Over and Above Estimate

## **PROJECT PROPOSAL**

We are providing a proposal for **USAFRC Baltimore Phase II BAS**. Our proposal is based upon the following documentation:

# USAFRC Baltimore BAS Status Report REV1

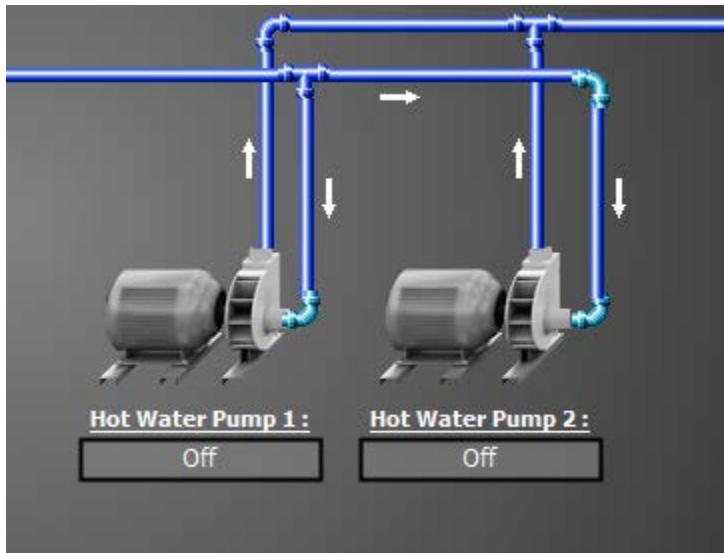
1. Chiller controls are incomplete. It appears that a BACnet connection to the chiller was planned but not connected. Wires are pulled from the chiller control panel out to the chiller but left unterminated.
2. Chiller package (including chilled water pumps) run standalone. The chiller is currently enabled/disabled by the switch at the chiller control panel and will run continuously if nobody attends to it. The BAS system shows a chiller command point which does not work:

3. The graphic also shows chilled water pump status which is also does not work.

4. Several chilled water flow meters are installed but none are reporting data at the BAS.
5. Pump Discharge Pressure and Pump Suction Pressure are unconnected points in the database that are not reading:

## Boiler Plant (Boiler 1 and Boiler 2)

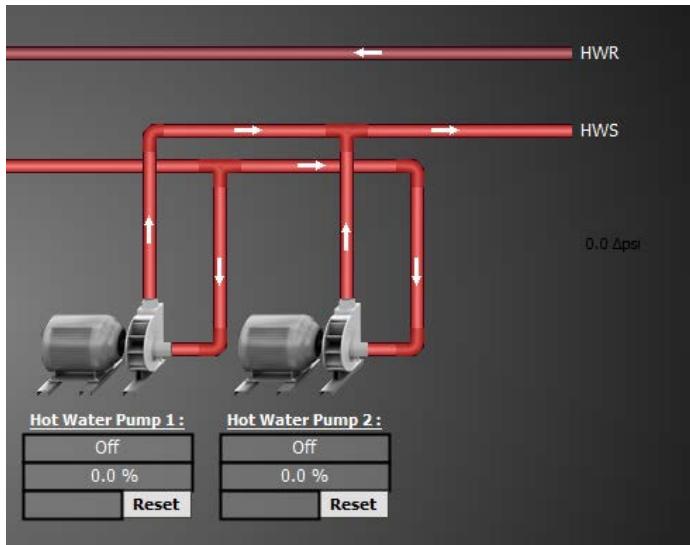
1. Boiler sequencing should be modified to extend boiler operation into the warmer months if high levels of indoor humidity are present.
2. The boilers are equipped to receive a supply water temperature reset signal from the BAS. This should be implemented as an energy saving strategy especially if the boilers are used during the summer months.
3. The domestic water pump has a start/stop schedule built in which is currently enabled for 24 hours a day operation. Consider changing the schedule to match actual building occupancy.
4. Boiler and pump rotation schedules are not shown on the graphics. This might be preferred depending on the experience level of the building operators.

- The system is equipped with a hot water flow meter which is not shown on the graphics. System flow reads very low. Hot water flow meter should be checked for proper operation.
- Boiler 1 Alarm point reading fault/stale and should be checked out.

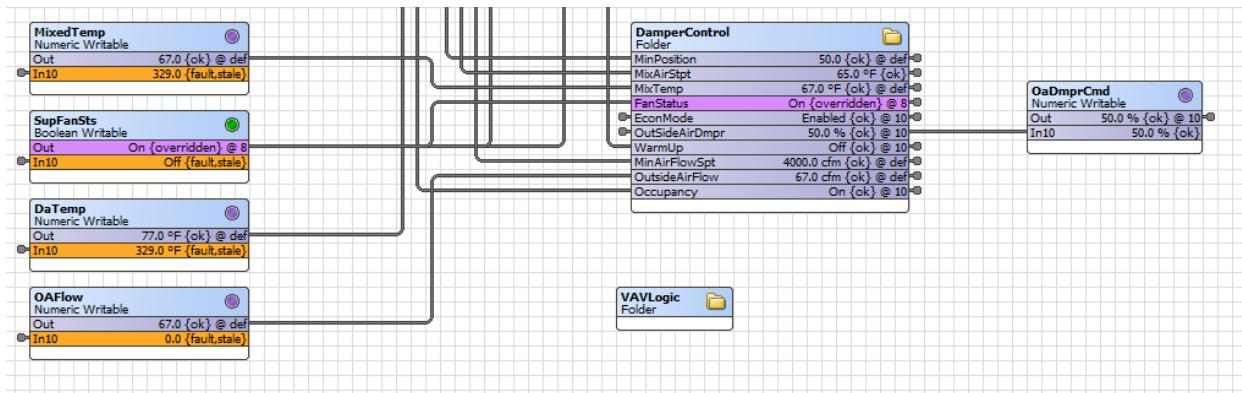
- Supply air fan status remains off when the fan is commanded to run. VFD will remain at minimum speed unless this point is overridden on. The fan proving device needs adjustment or replaced to correct this deficiency.
- Existing AHU mixed air damper control takes outside air airflow into control logic. There is no airflow station installed. This portion of software and mixed air damper control should be corrected:

- This building appears to have generally low occupancy. Proper utilization of CO2 detectors would be an added benefit to optimize mixed air damper control / minimum damper position when outside air conditions are not favorable to economizer.

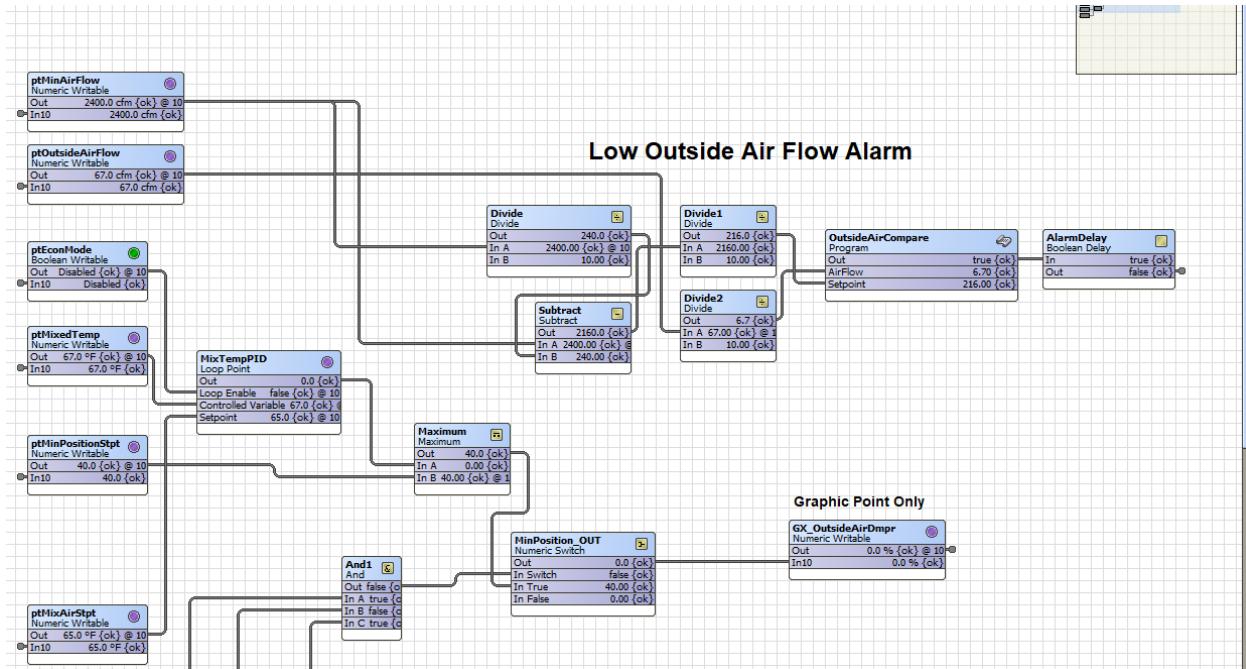
1. AHU-2 cooling valve actuator has failed and needs to be replaced:

2. There is no airflow station installed. This portion of software should be corrected:

3. This building appears to have generally low occupancy. Proper utilization of CO2 detectors would be an added benefit to optimize mixed air damper control / minimum damper position when outside air conditions are not favorable to economizer. Existing mixed air damper sequencing should be verified.

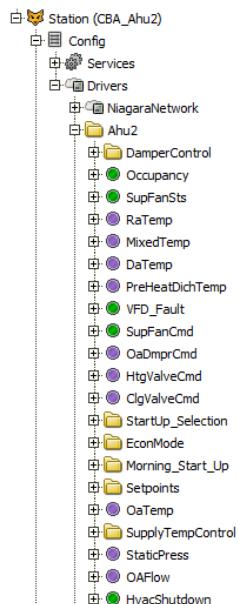
4. The health of the Ndio hardware should be investigated. Point values are updating erratically.

5. Points for Static Pressure and VFD Fault are found in the point database. This is a constant volume AHU:

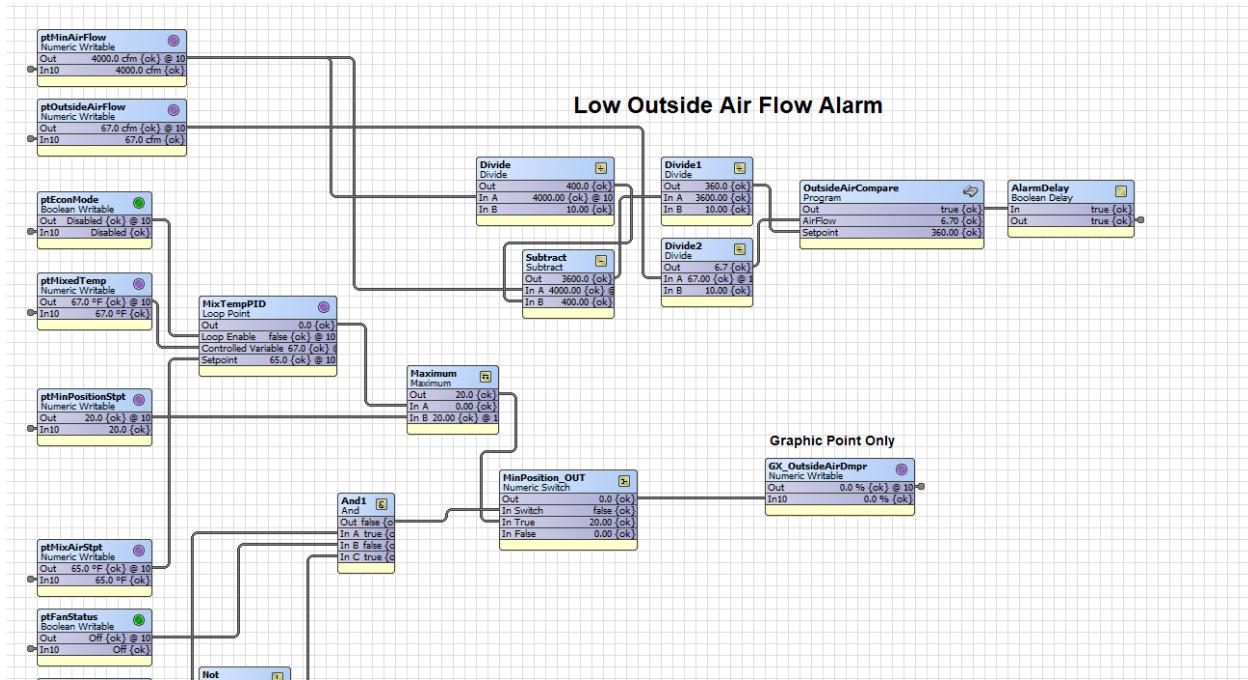
1. AHU-3 heating valve actuator has failed and needs to be replaced:

2. There is no airflow station installed. This portion of software should be corrected:

3. This building appears to have generally low occupancy. Proper utilization of CO2 detectors would be an added benefit to optimize mixed air damper control / minimum damper position when outside air conditions are not favorable to economizer. Existing mixed air damper sequencing should be verified.

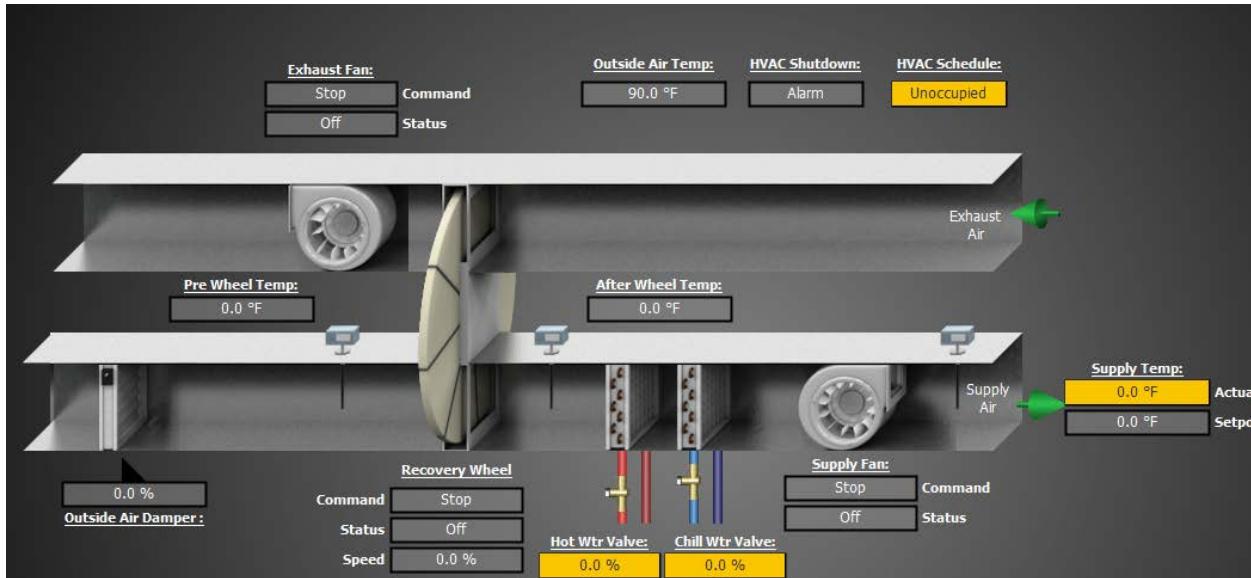
1. The energy recovery wheel remains on when the unit shuts down.
2. Graphics do not show the supply air and exhaust air isolation dampers. These are modulating dampers but really should act as 2 position open/closed dampers only. End switches on damper actuators are recommended to prohibit fan operation unless dampers are proven open.
3. The bypass damper is not shown on the graphics.
4. The unit outside air damper was found to automatically modulate and starve the supply fan when closing. Either the outside air damper or bypass damper must be open to prevent supply fan starvation. During normal unit operation the outside air damper should be 100 percent open to make up for exhaust air exiting from the building:

5. ExhaustFilterS point is reading fault/stale.
